**STAFF REPORT
SPECIAL CERTIFICATE OF APPROPRIATENESS
FOR THE PROPERTY AT
415 ARAGON AVENUE
A LOCAL HISTORIC LANDMARK**

Proposal: The application requests design approval to correct work without a permit with additions and alterations to the residence and detached garage, and sitework.

East - Sheet A.6

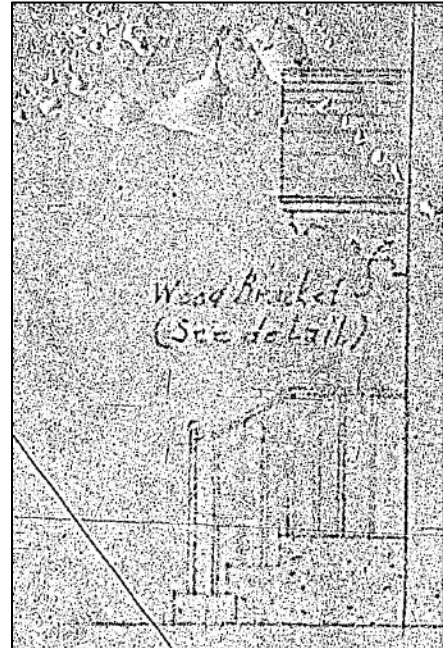
At the south end of the existing residence, the proposed copper-clad door hood is visible at the front door. It is noted to project 3’-0” from the south façade. Note that, as drawn, it does not match the original design intent (see Figures 6). The carport with two arched openings obscures a portion of the existing residence. To the north is the flat-roofed master bedroom addition. The addition façade is largely blank except for a pair of casement windows (no protruding sill, typical on the additions). Beyond, the detached garage is visible with the roofed connection to the back terrace of the residence. At the garage – to be converted to living space – a window is proposed to be relocated and a door opening removed.

13. Provide construction details and sections of the front door hood. Work with Staff to ensure it is a replication. If this cannot be achieved, the element should be eliminated rather than adding a conjectural feature.
14. Reduce the parapet height of the master bedroom addition to be lowered to be more in keeping with the parapet height on the north façade of the home and eliminate the corner pieces at the south façade.
15. Stucco texture of the new addition should be differentiated from the existing residence. A score line is to be added to demarcate the location of new construction.
16. Recess of original garage door opening to remain.
17. If the floor elevation of the detached garage is too low for living space , staff does not support the raising of the roof/parapet to achieve a raised floor.
